A G E N D A

Architectural Review Board

April 26, 2016

PLANNING CONTROLS DIVISION

753 Thorn Place

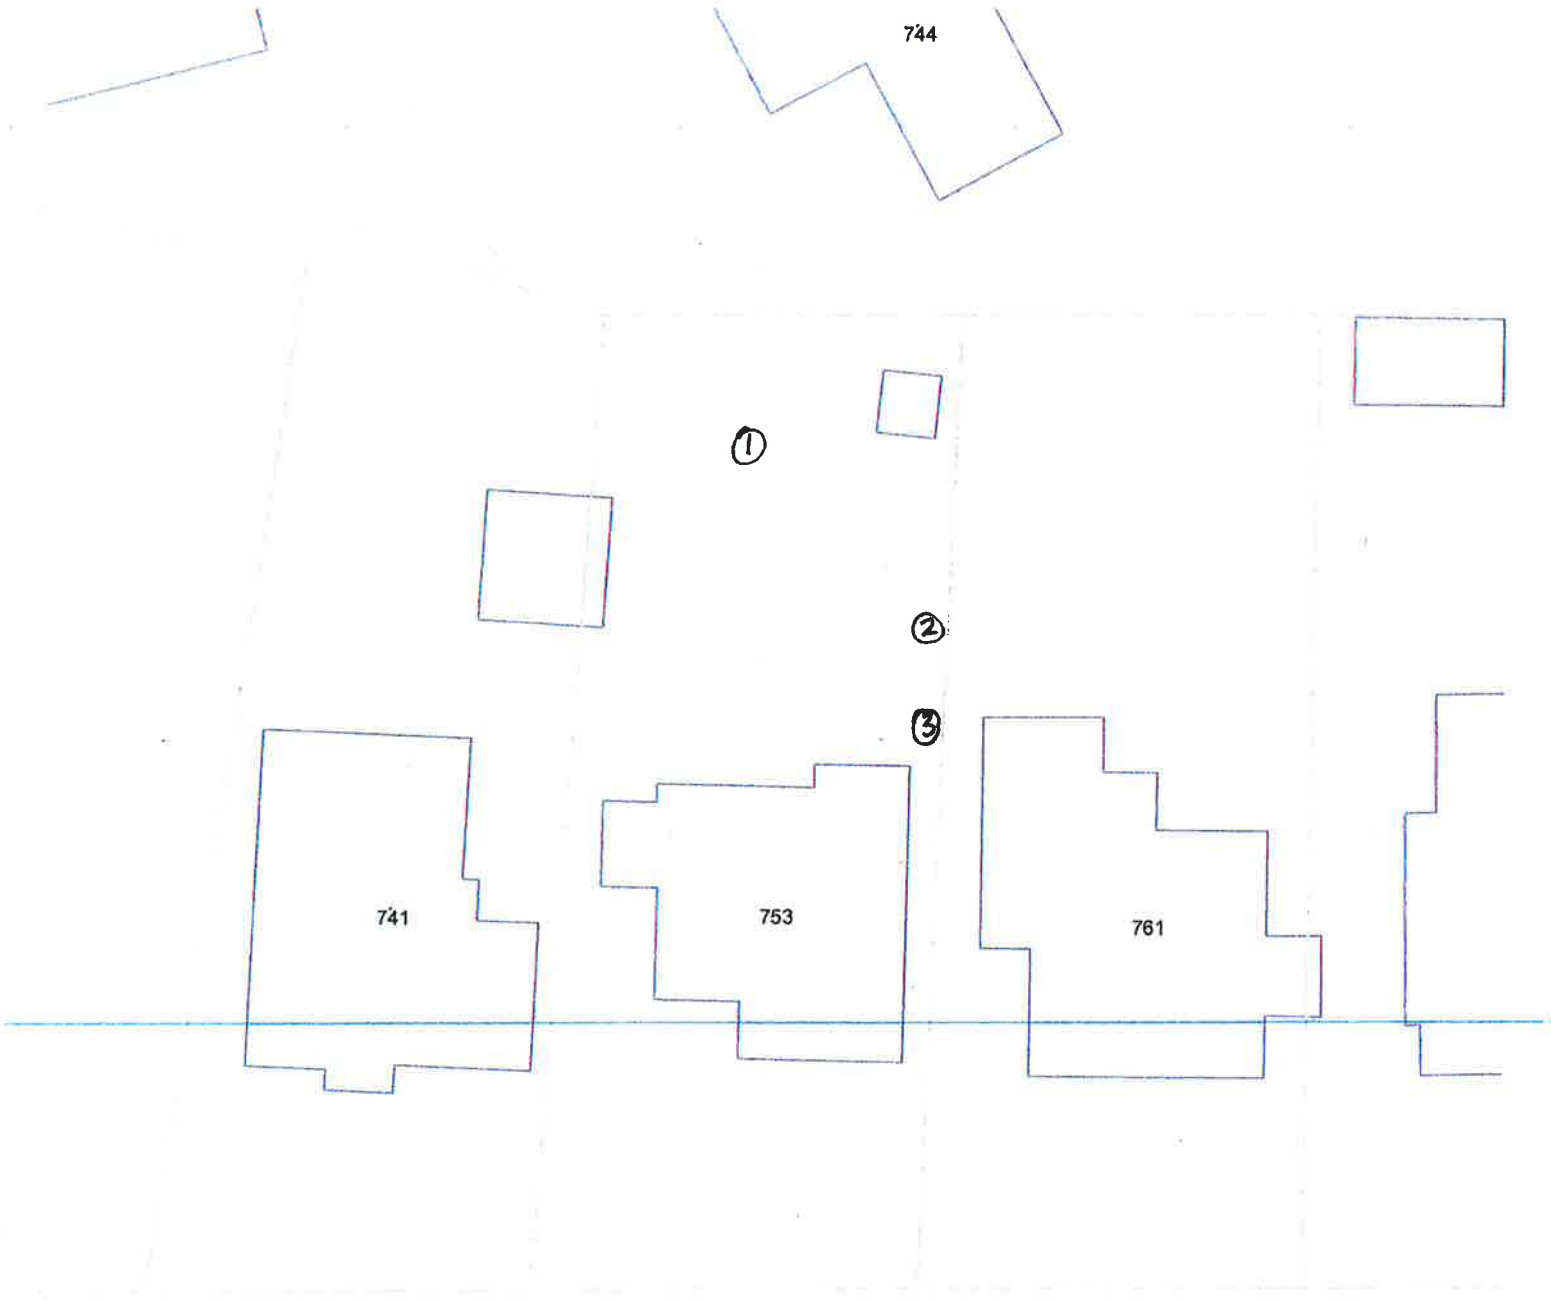
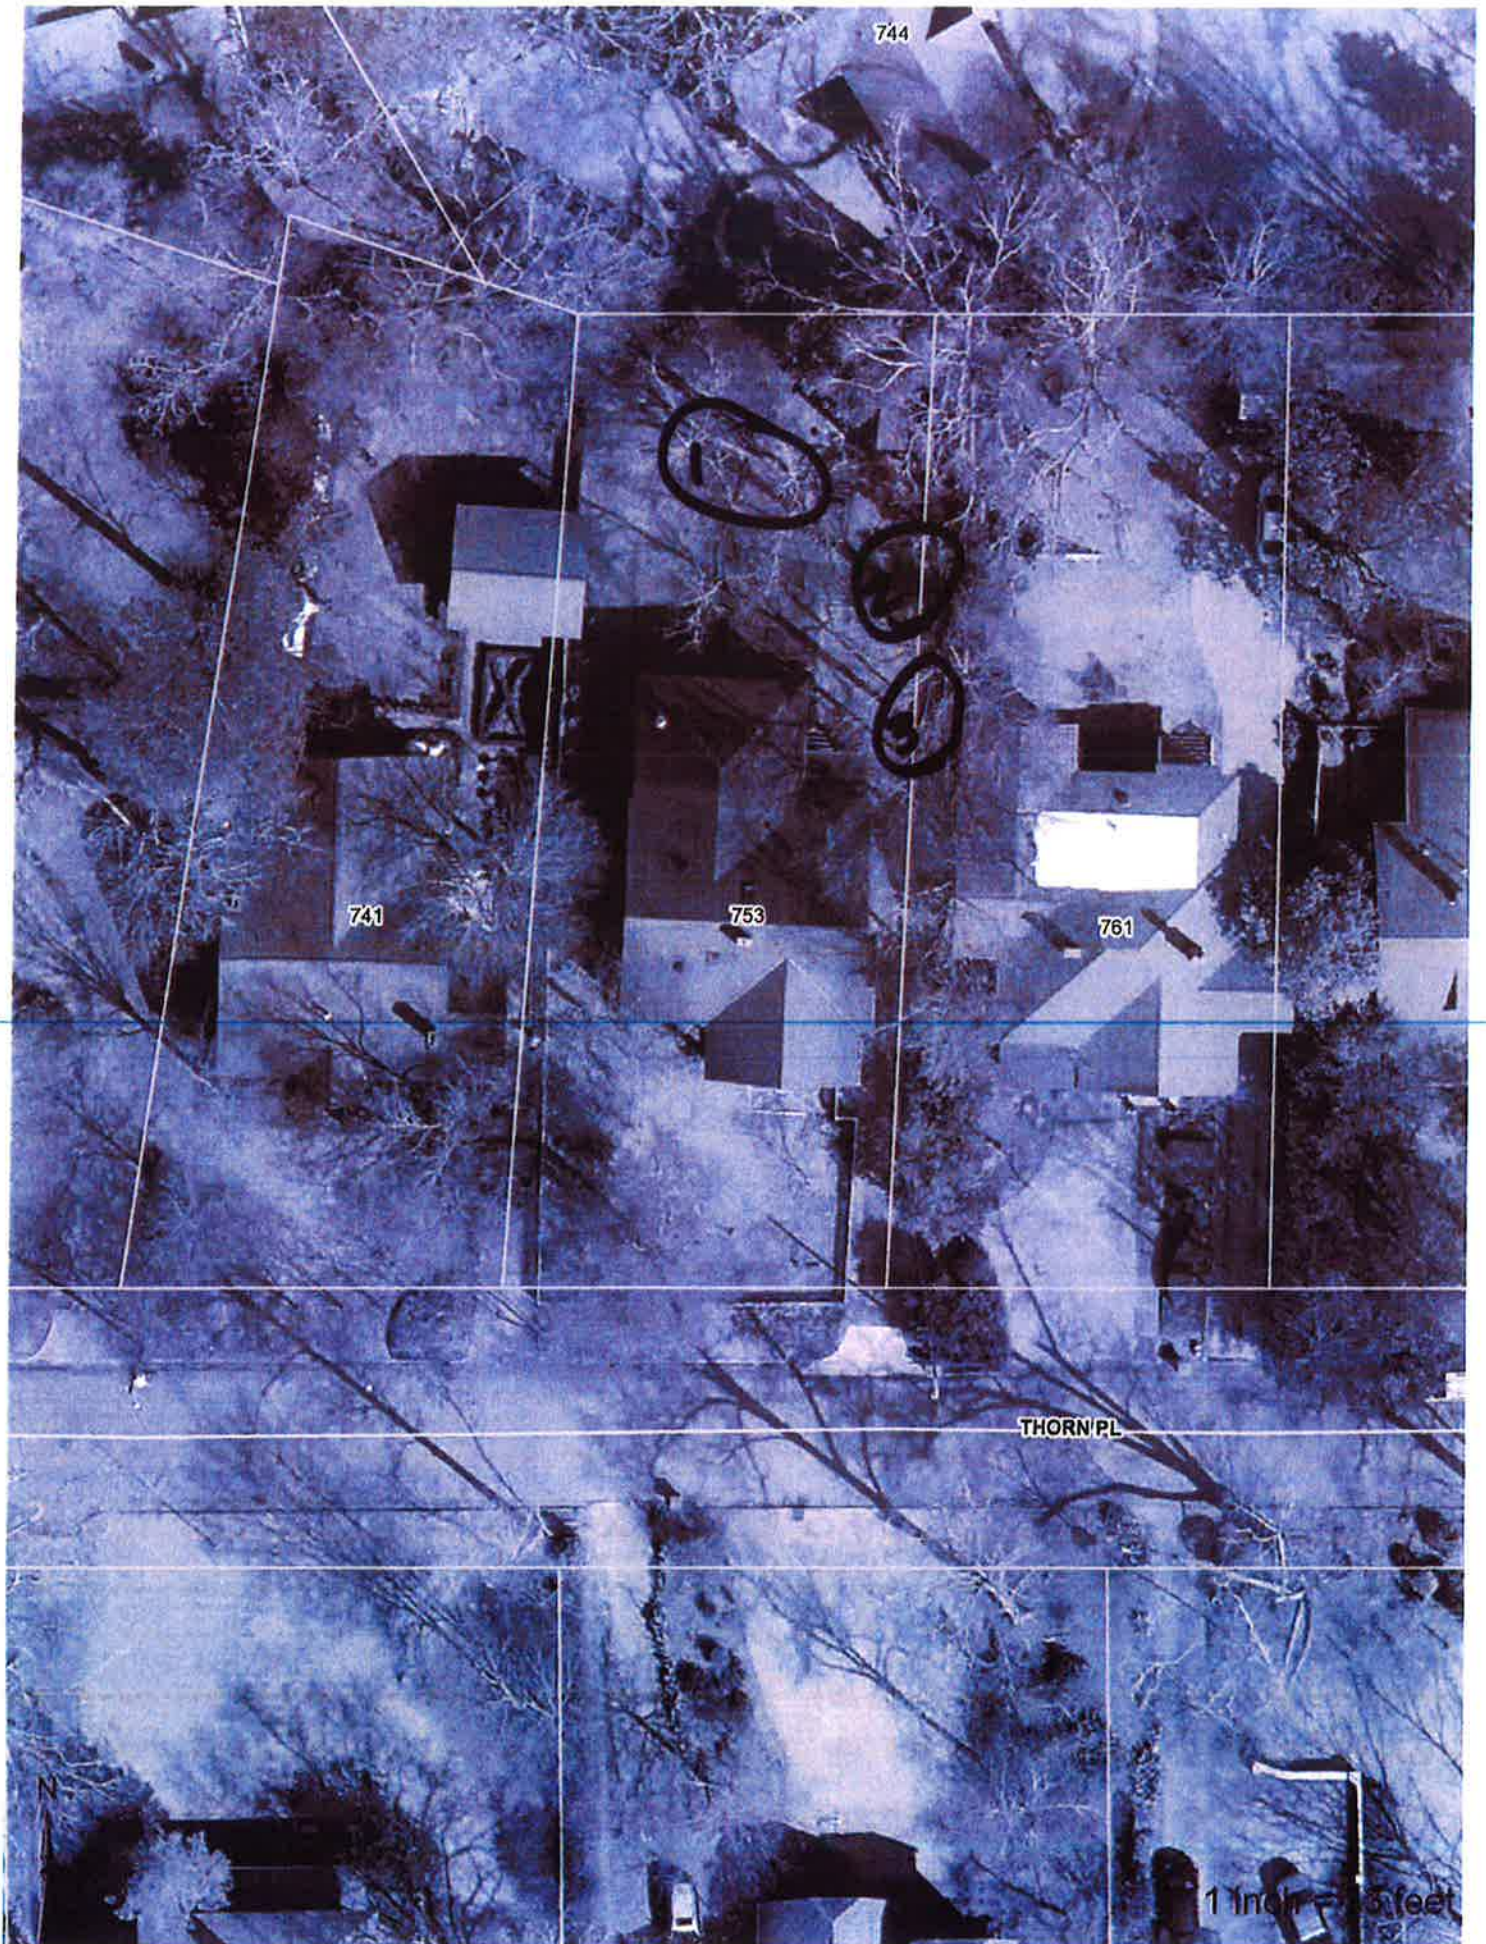
REMARKS: The petitioner is requesting permission to remove a 24" pecan tree from the rear yard, and for re-approval of the removal of 2- 24" hackberry trees on the property line (approved June 2013).

- Tree #3 is healthy. Otherwise no objection.

660 Cloverdale Road

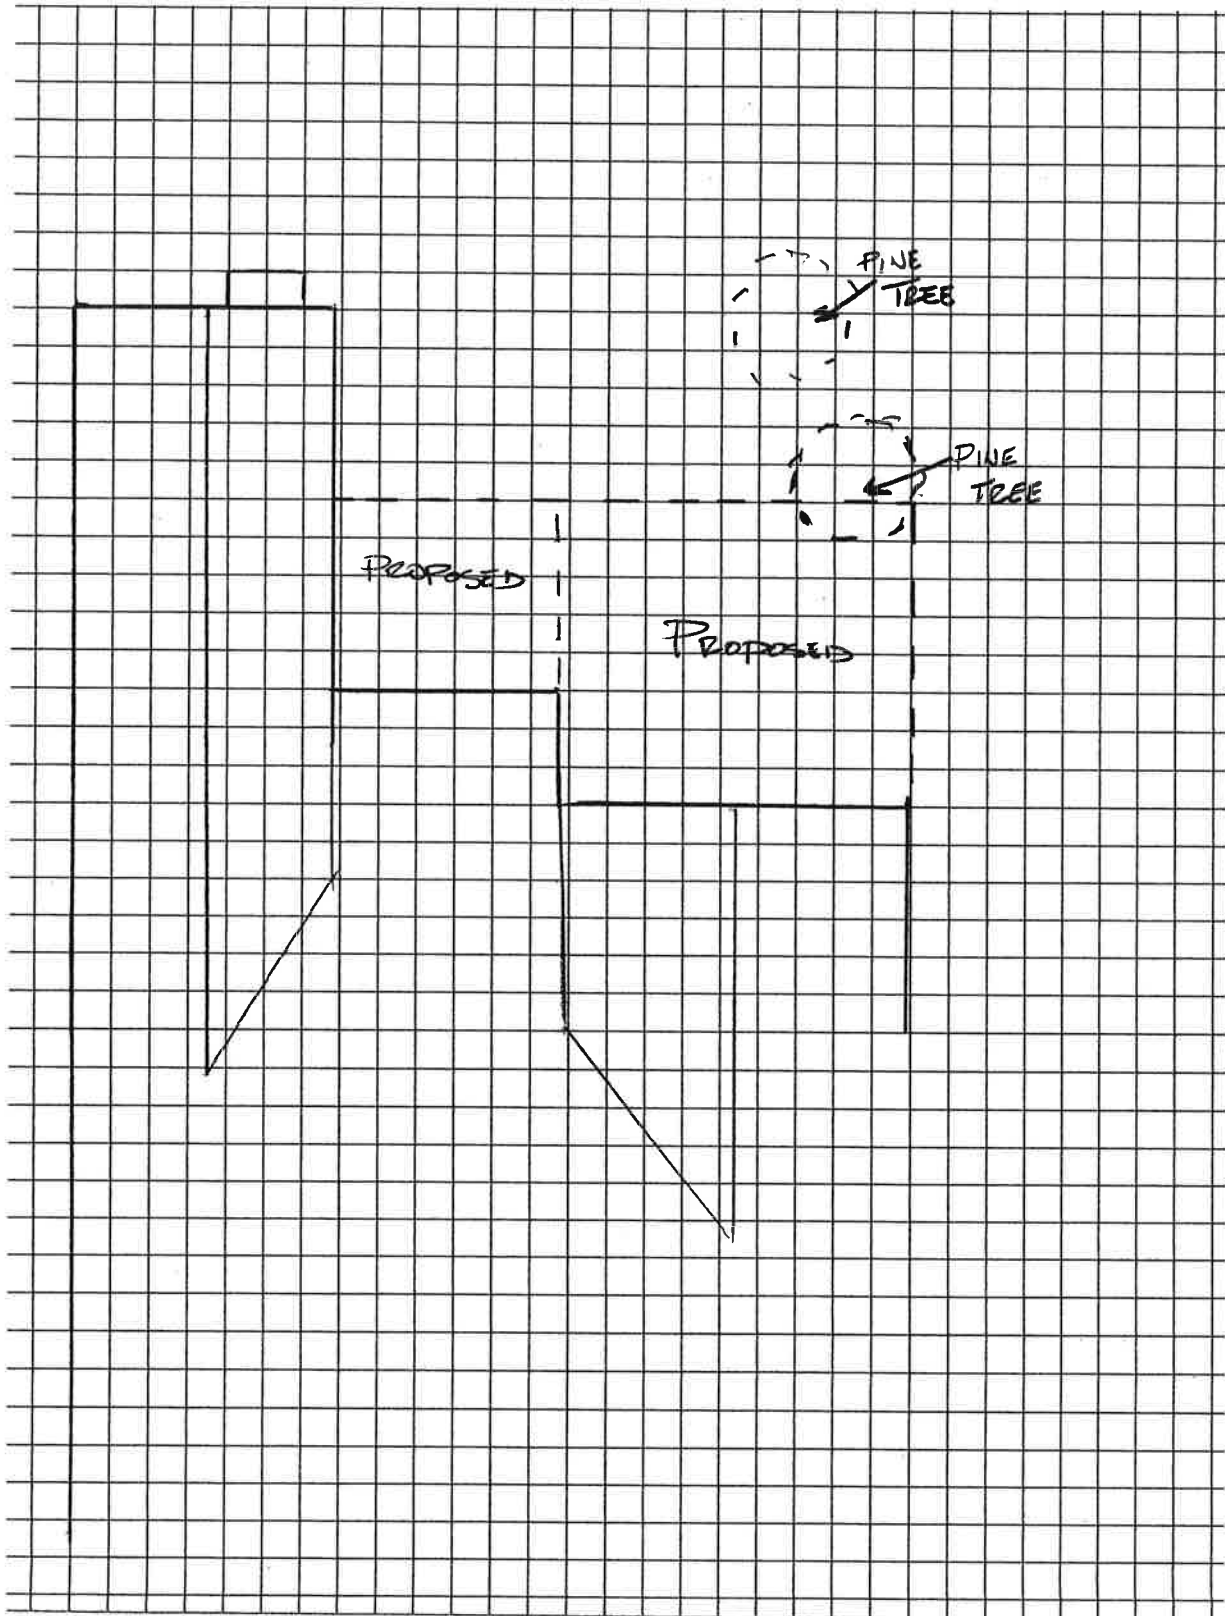
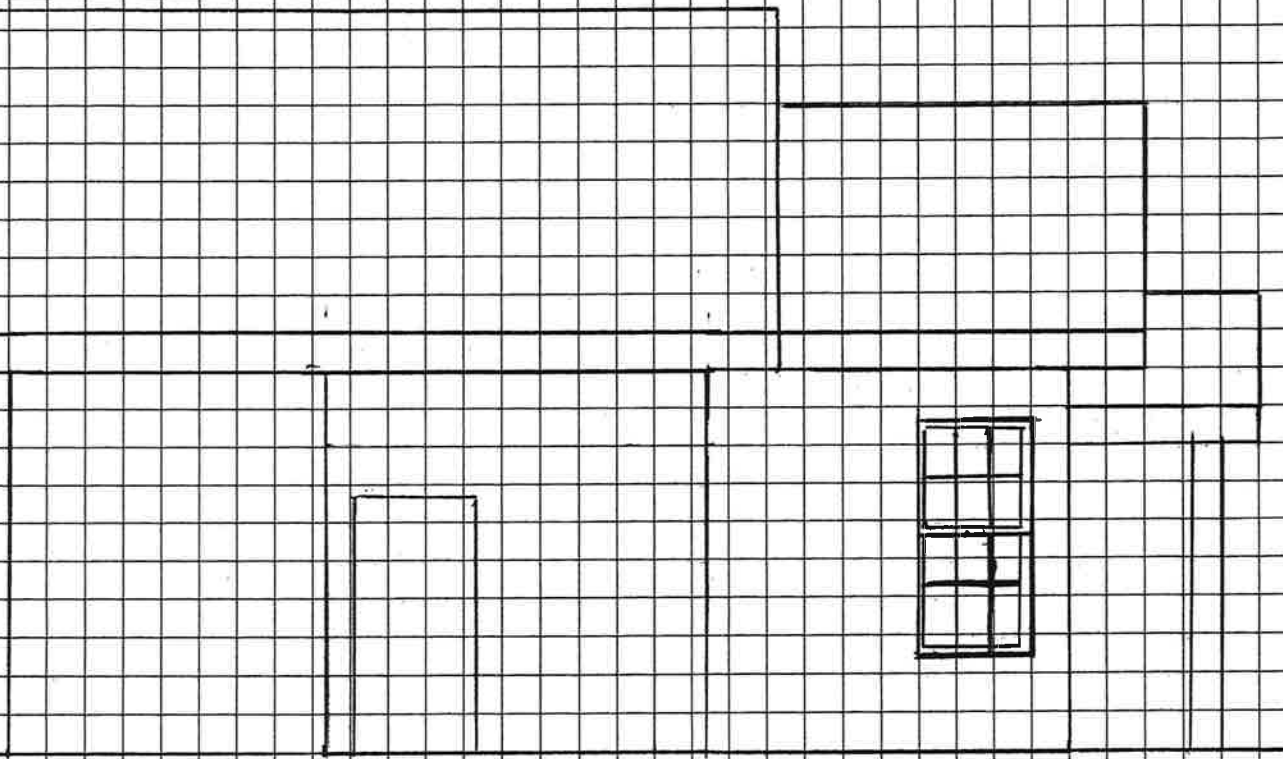
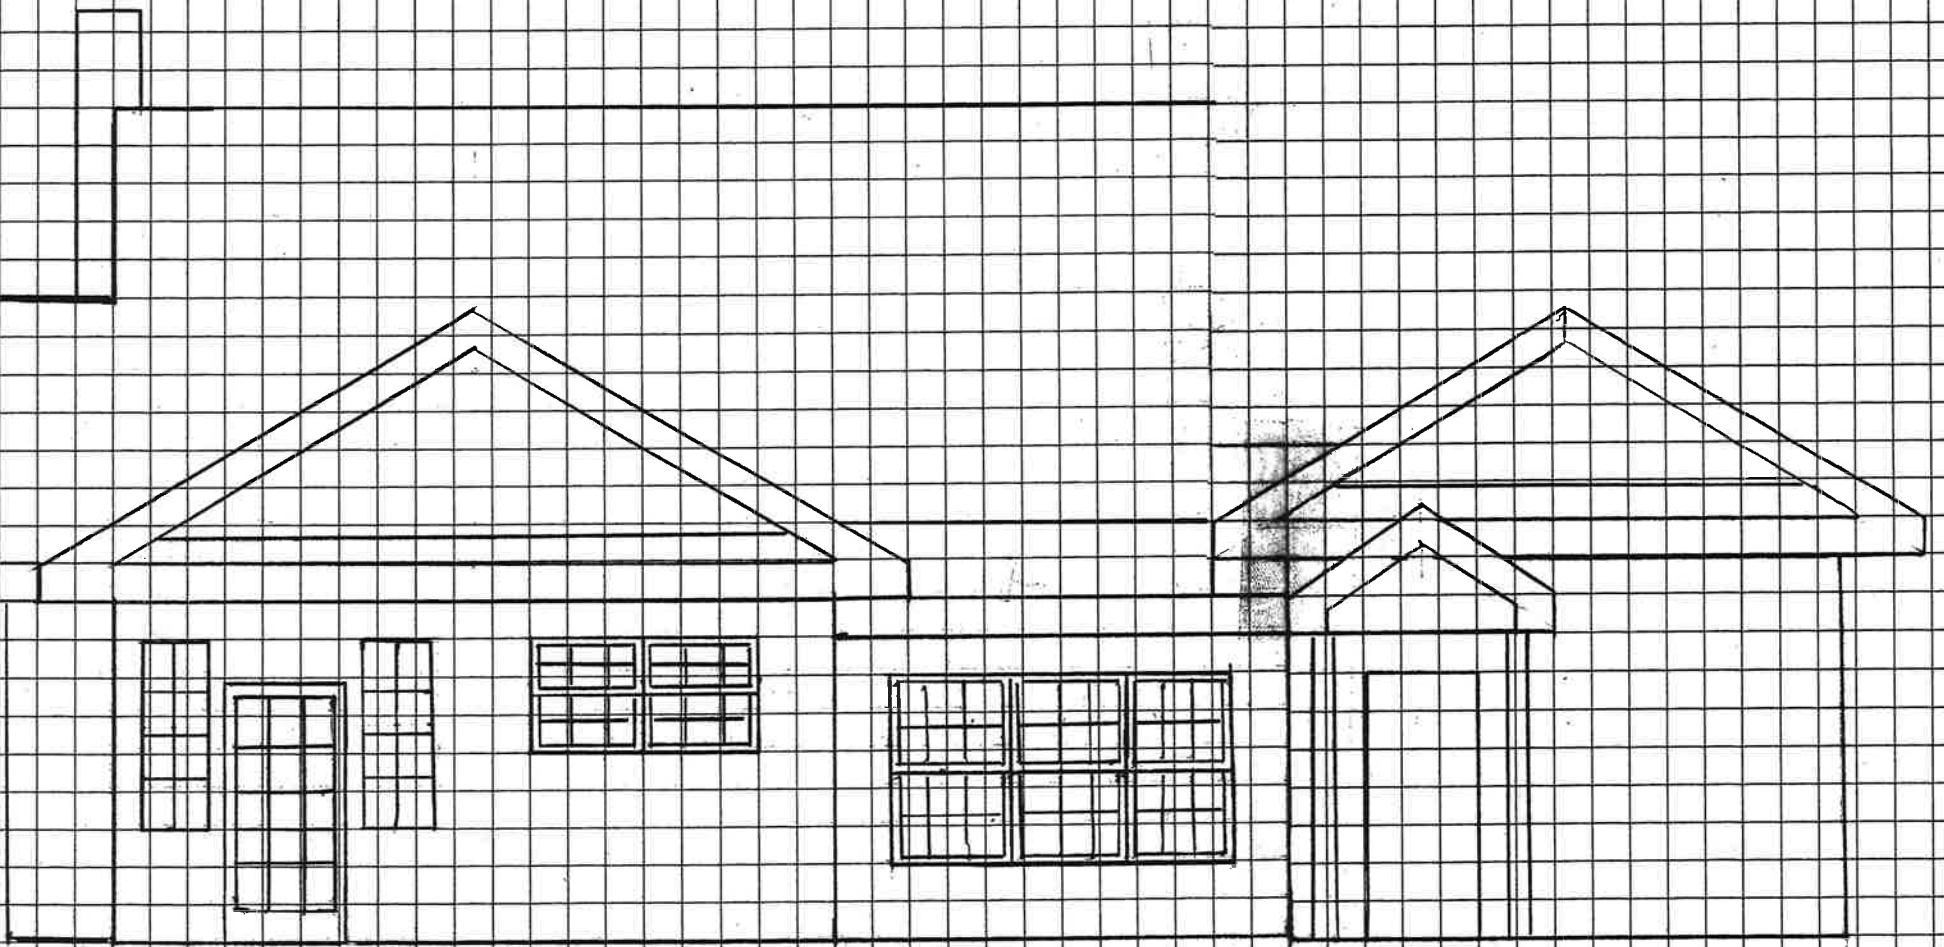
REMARKS: The petitioner is requesting permission to add a laundry room on the rear where there is an existing bump out in the rear ell, and to extend the roof line of the gable on the rear to create a covered patio area. The laundry room will extend 10'; the gable extension will be approximately 16'3" and end flush with the laundry room addition. All materials to match existing.

The petitioner is also requesting permission to remove two pines tree at the rear of the house due to foundation issues. The petitioner will submit a landscape plan to the Urban Forester at the end of the renovation project to address any tree replacement issues.

- Pines are healthy and not causing foundation problems.
